Planning and Zoning Board Agenda August 11, 2020

- C. Site Plan – Burger King (16130 NW US Highway 441): A request by Robin Kendall of Quality Dining, Inc., applicant and agent, for T&H Property Group, LLC, property owner, for consideration of a Site Plan to construct a ±3,349 square foot quick service restaurant with associated parking, stormwater, landscaping, and site improvements on a ±1.19 acre subject property. Tax Parcel Number 03061-004-001 (Quasi-Judicial Hearing).

PREPARED BY: Justin Tabor, AICP, Principal Planner

NOTES:

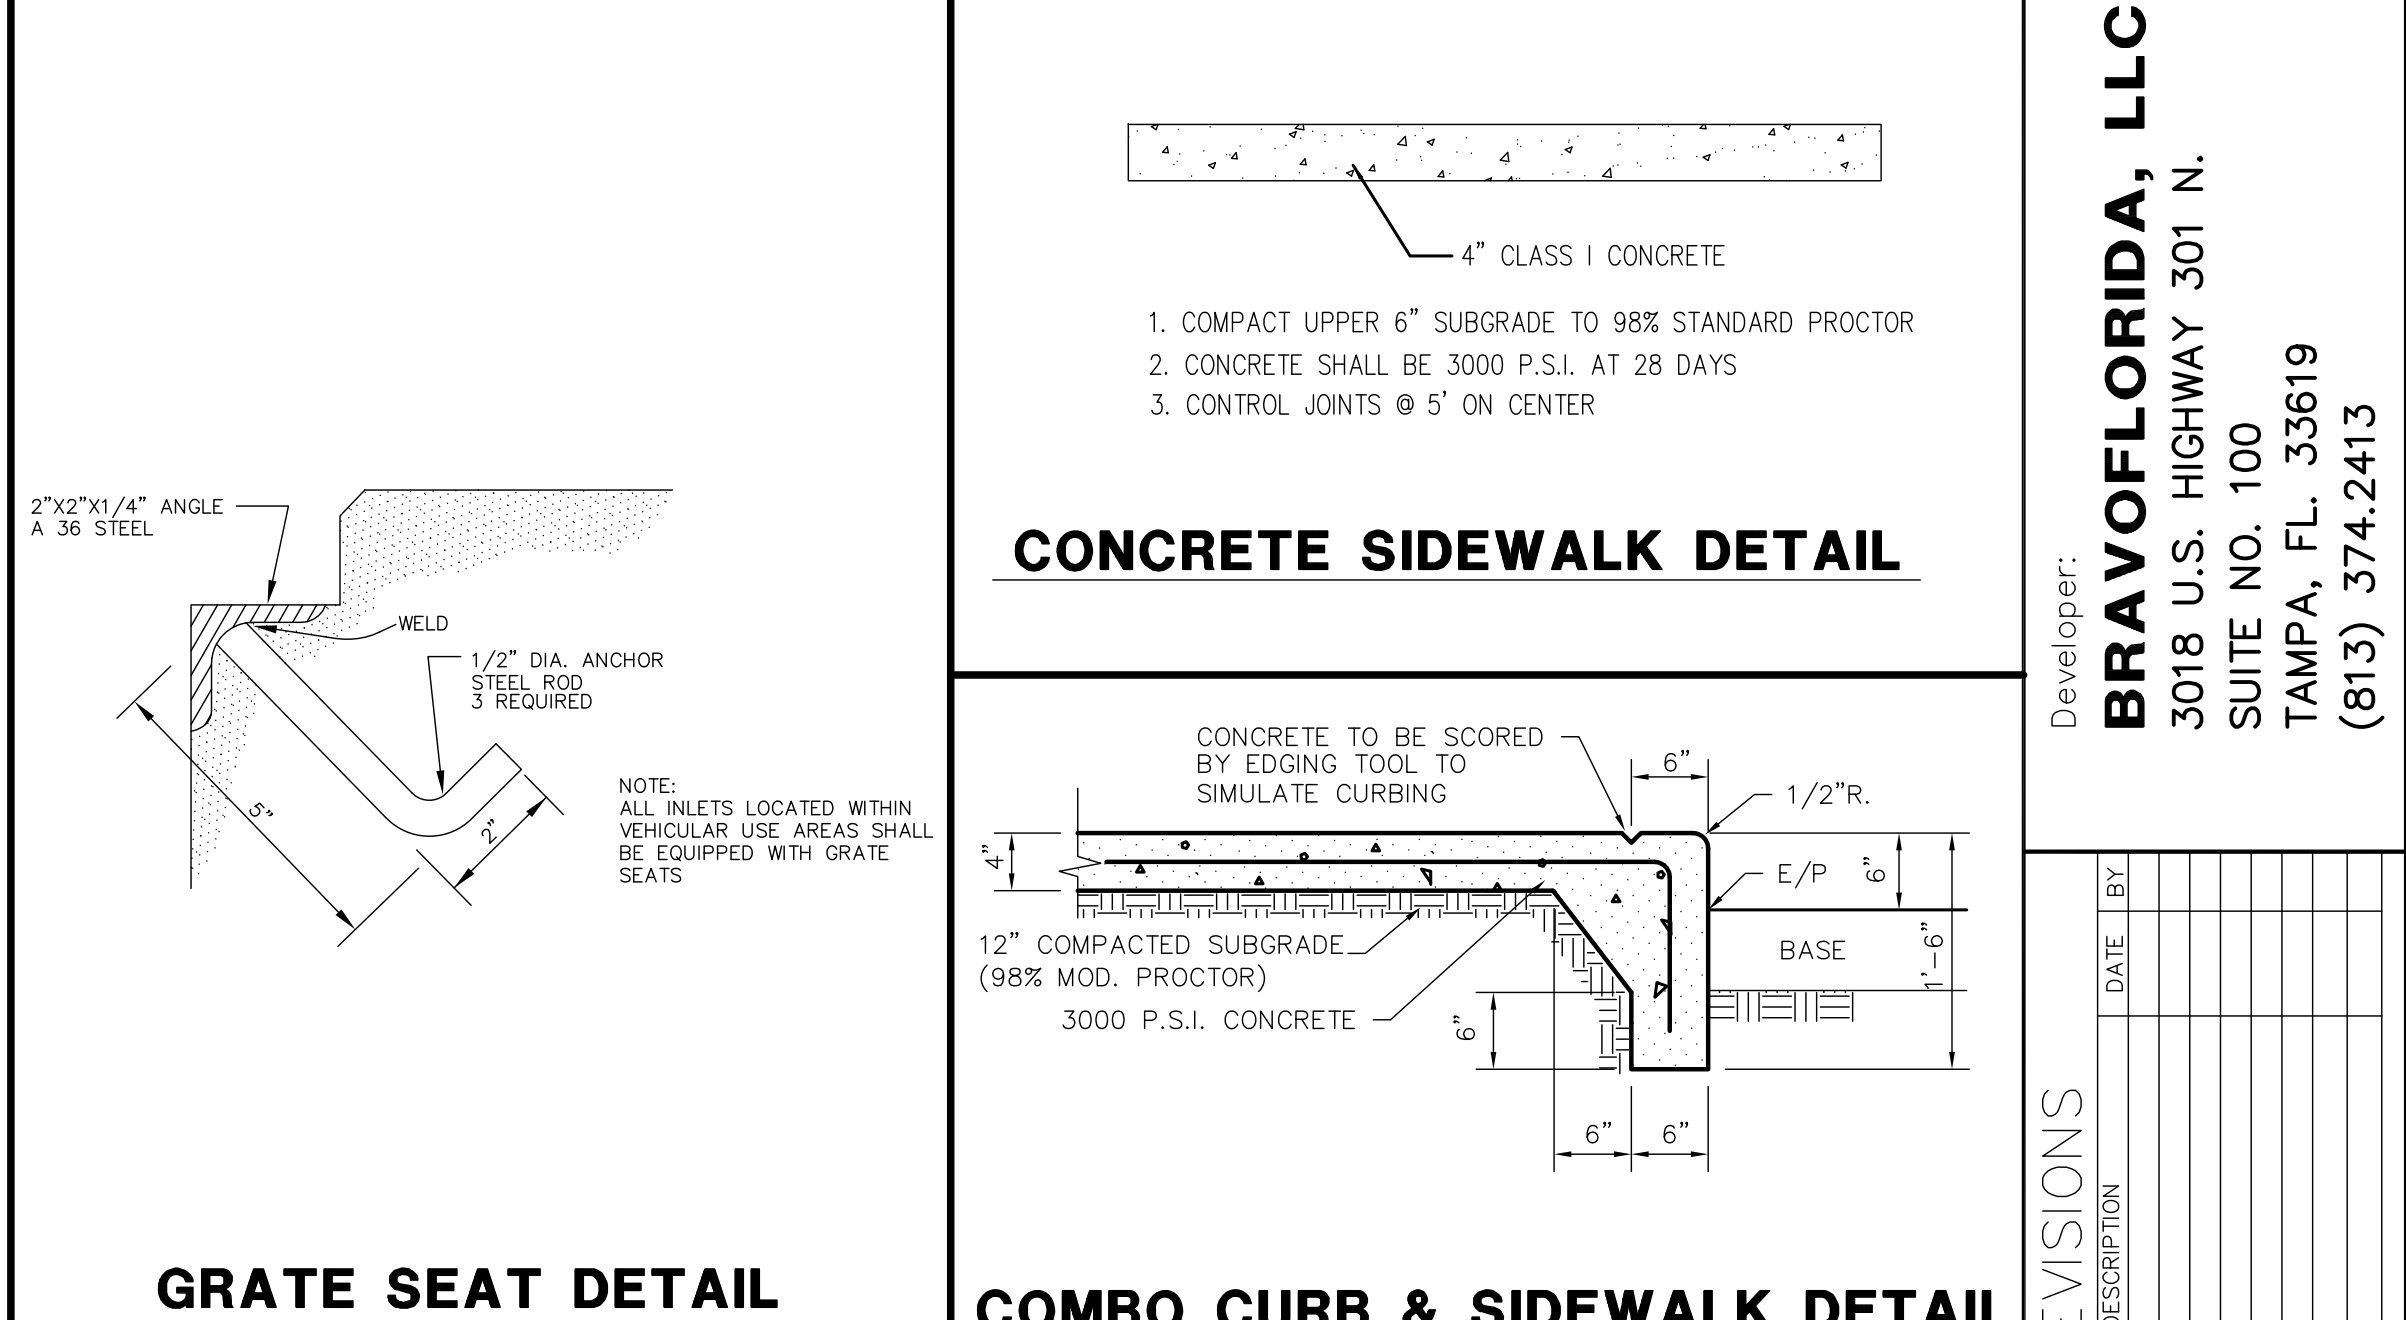
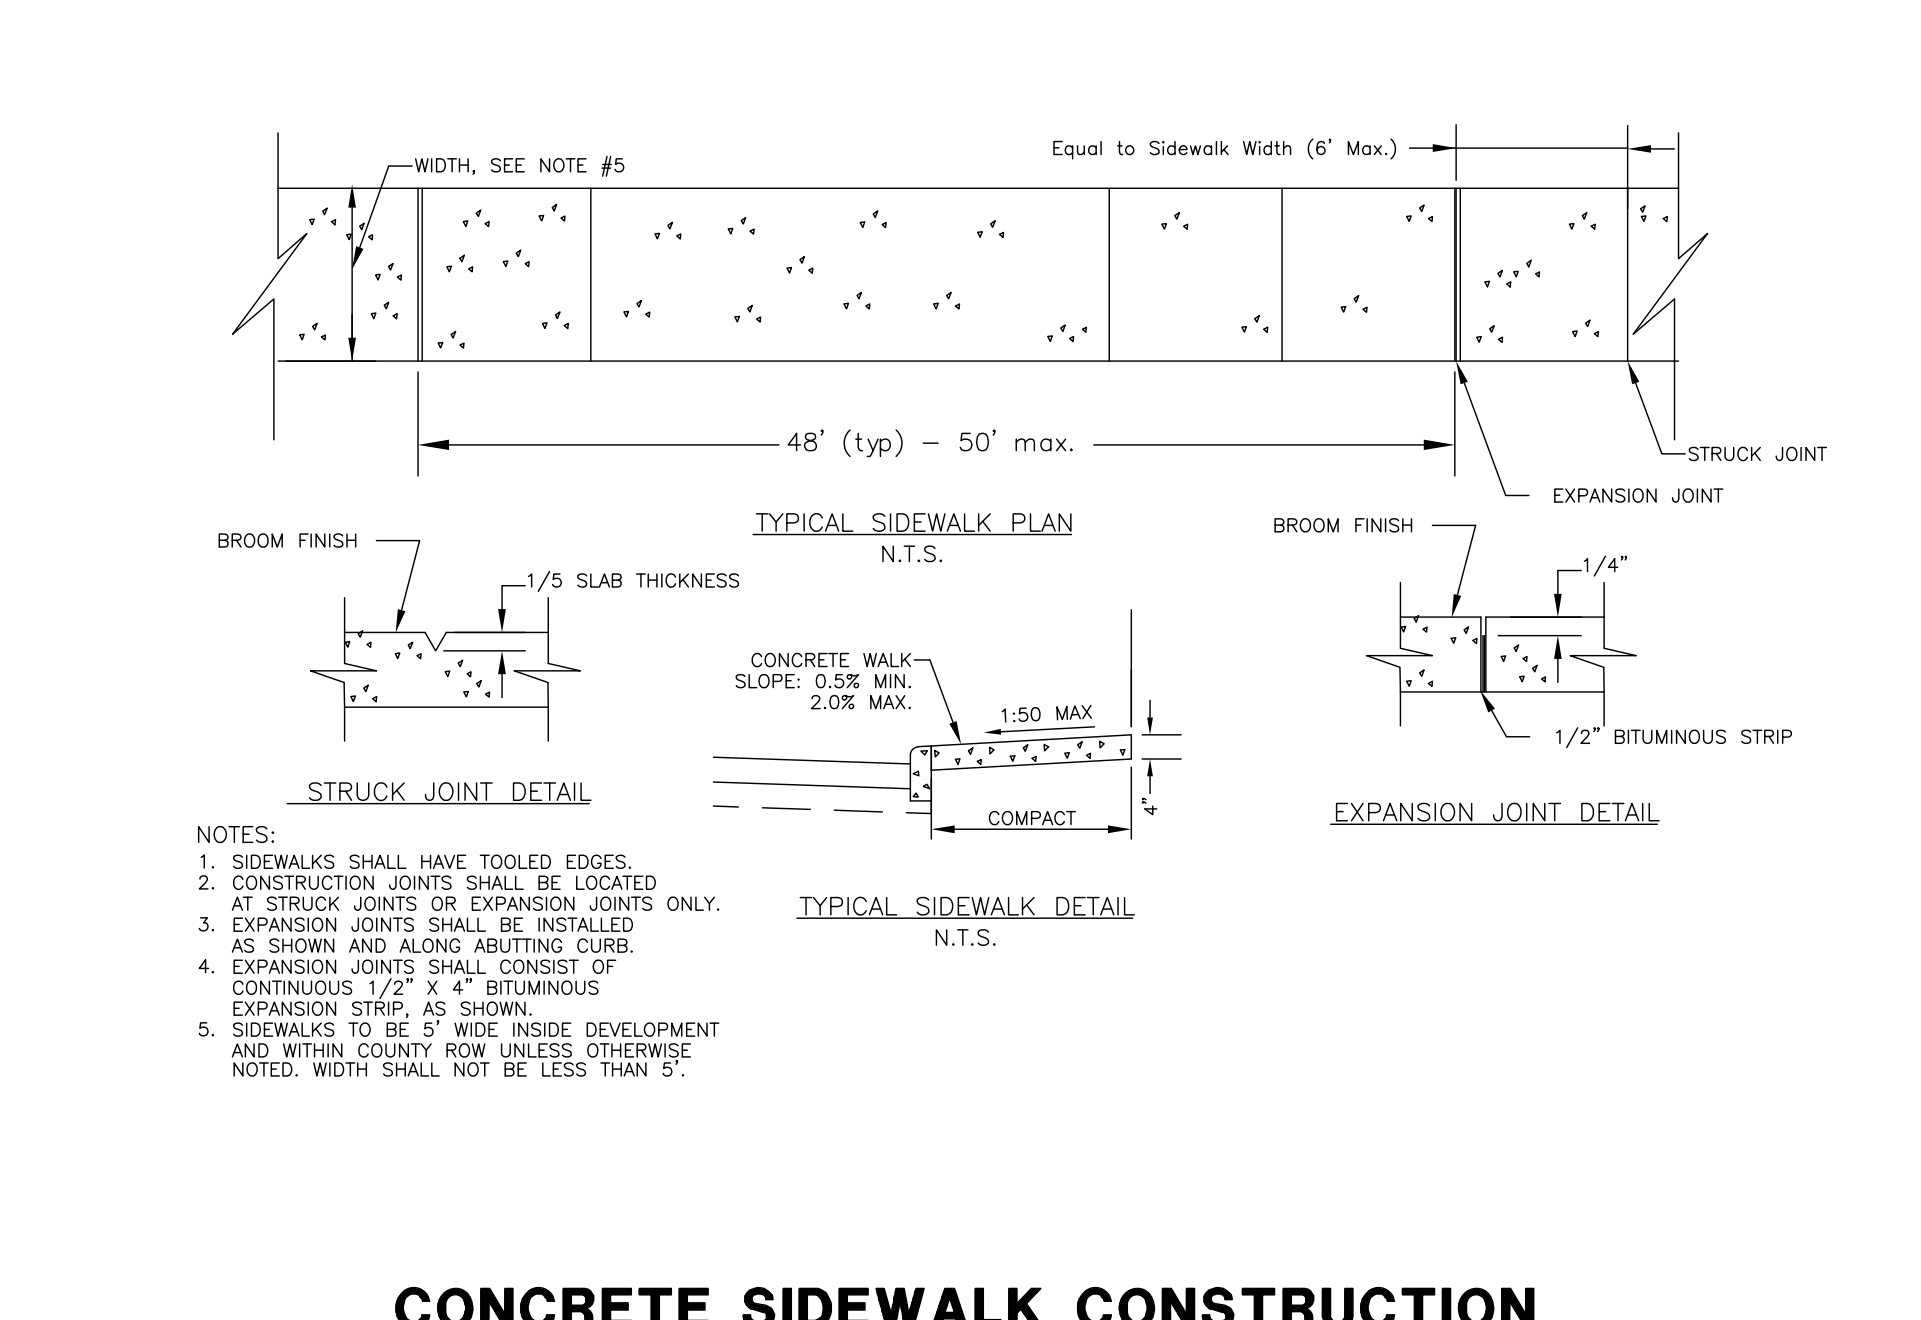
4.	Comment on Jan 12th Submittal • Sheet C06, Note 4: Please review meaning of “conveyed”? Should it instead be “connected”? • Sheet C06, General Utility Note 9: Please add “electric service”. • Sheet C06, Please add the following general note: “In the right-of-way, to both the 2-inch water line and 6-inch gravity sewer main, install 2-pair, 10- gauge tracer wire with enough unwrapped wire to allow connection to test device.”

5.	Comment on Jan 12th Submittal • Sheet C06, Electrical: The electric service will not be provided from the overhead line and power pole. Instead show a pad-mounted transformer close to where the power pole is. Also, show a new underground electric line from the Utility Box to the pad-mounted transformer. • Sheet C05, Electrical: Please add the following General Utility Note: “The City of Alachua will procure and install the pad- mounted transformer, the pad and also the conduit & conductors from the utility box to the pad-mounted transformer. This work shall be done at no cost to the City, who will backcharge the Contractor. All electric work “downstream” the transformer shall be the responsibility of the Contractor”.

6.	Comment on Jan 12th Submittal • Sheet C06, Electrical, The City of Alachua will provide 277/460 Volt 3-phase electrical power at the transformer. Please confirm that this is acceptable. Other power types may be available. • Sheet C06: Please provide a load schedule so that the City can size the transformer. When will the load schedule be available?

7.	Comment on Jan 12th Submittal • Sheet C06, Cleanout: A cleanout is shown within the property line in the lower left. Please either: • Relocate the cleanout so it is in the right-of-way, or: • Keep as is, but add a second cleanout in the right of way, or. • Keep as is, but grant an easement to access the cleanout.

NO.	COMMENTS
8.	Comment on Jan 12th Submittal Sheet C06: Where the new 2-inch water line connects to the existing 16-inch DIP, a corporation stop is called out. As per CoA standards, please replace with a 2-inch resilient seat gate valve with valve box.

9.	Comment on Jan 12th Submittal Sheet C06: A dashed line is shown about 10 feet within the property line. What does it represent? Please show on legend sheet.

Response: Yes. See revised sheet C06.
